SYSTEM SUPPORT DIRECTIVE

SSM-ASR9-016

ASR-9 SERIAL INTERFACE SYSTEM (ASIS) PHASE II DUAL BOARD

07/14/2003

FIGURE 1. SCIP CABINET, RIGHT REAR VIEW, DOOR REMOVED

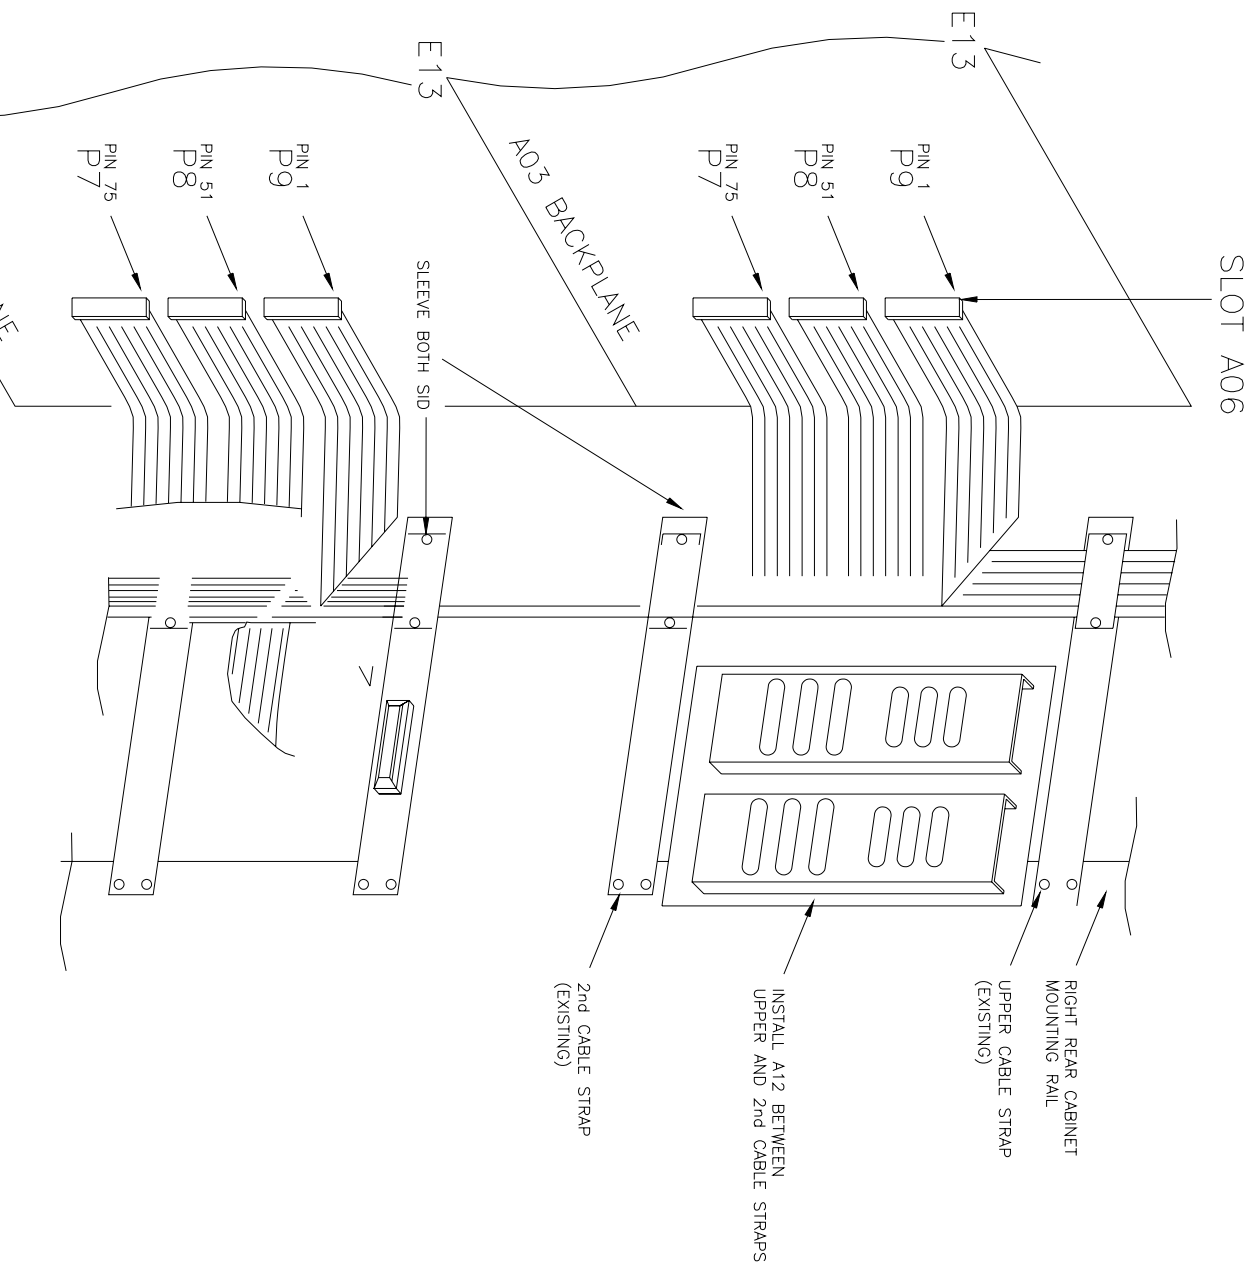
(7) Install cable mount (item f) and dress cables in cabinet as shown in Figure 1.

FIGURE 1. BACKPLANE CONNECTIONS

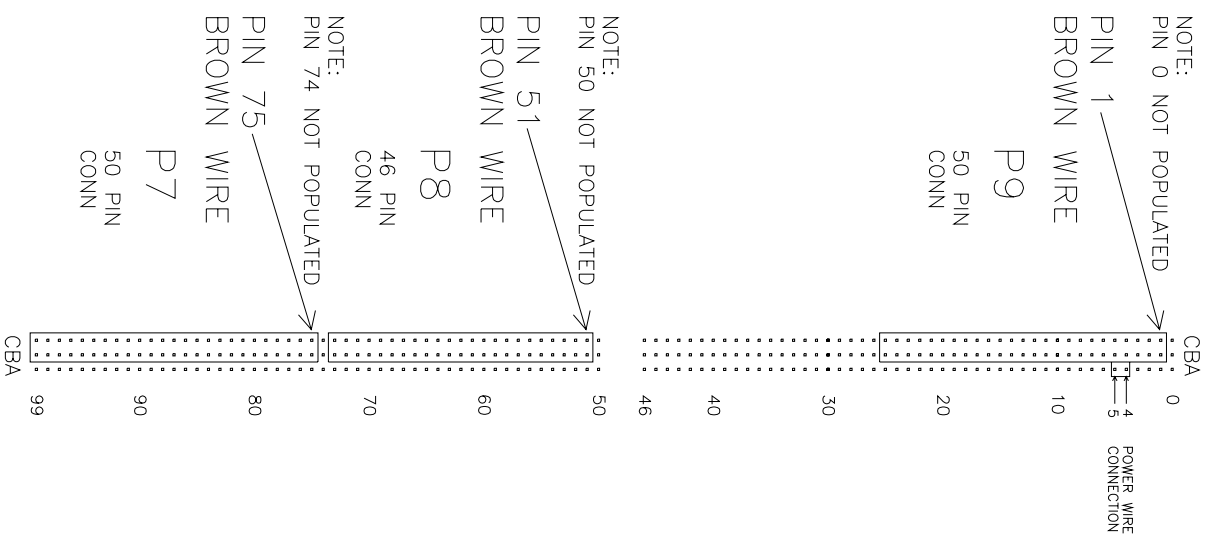
(4) Refer to the figures in appendix 2 and 3. Connect cable A12P9 to SCIP B backplane slot A4 XA6. Pin 1 (brown wire) of cable to Pin C01 of backplane.

(5) Connect cable A12P8 to SCIP B backplane slot A4 XA6. Pin 1 of cable to Pin C51 of backplane.

(6) Connect cable A12P7 to SCIP B backplane slot A4 XA6. Pin 1 of cable to Pin C75 of backplane.

FIGURE 3-1. ASIS-PHASE II CONTROLS AND INDICATORS

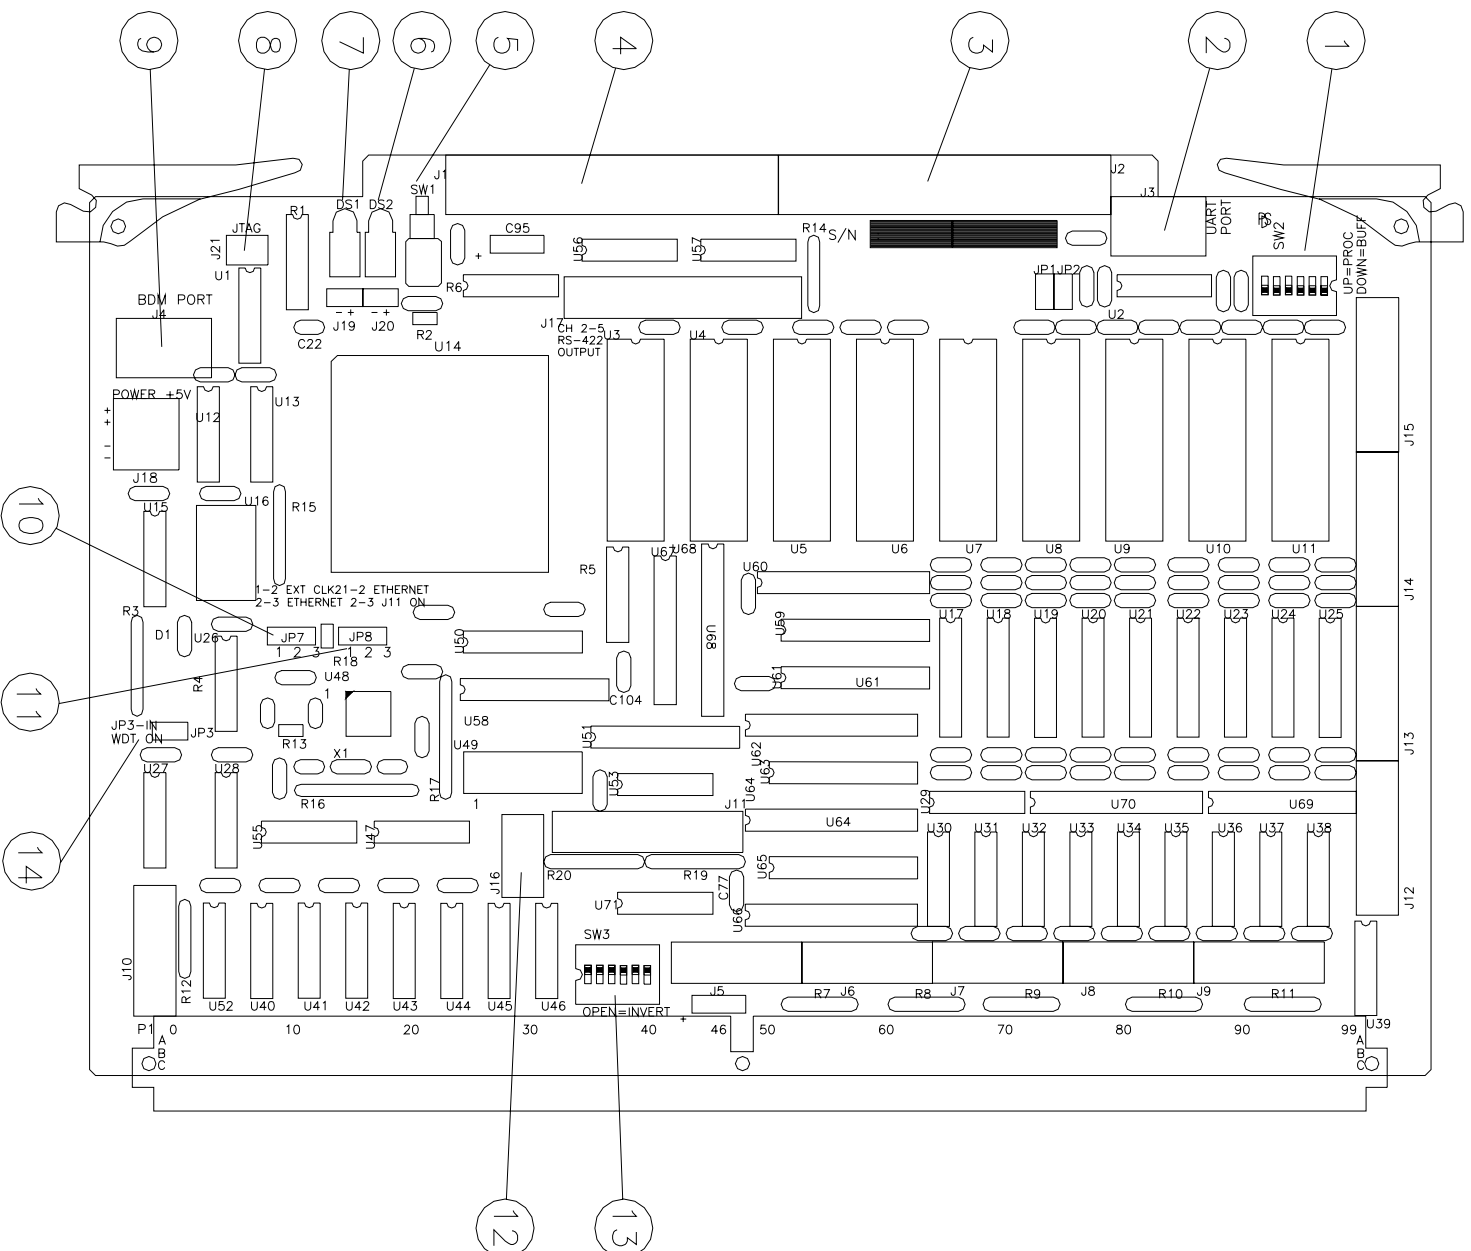
d. Refer to TI 6310.31 SUP1 section 3.2. (Table 3-1 and figure 3-1 in appendix 4.) Verify the ASIS II circuit card (item a) is configured as follows:

SW2 positions 1-6 closed (levers pushed down toward circuit card) bypass the onboard processor.

SW3 positions 1-6 closed. (Data polarity normal)

JP3 installed. (Enable watchdog timer)

JP7 - jumper 2-3. (Ethernet Port Clock is available)

JP8 - jumper 1-2. (Ethernet Port is available)

This configuration is the ASIS I mode, which disables the processor functions for all outputs on the adapter box, A12.
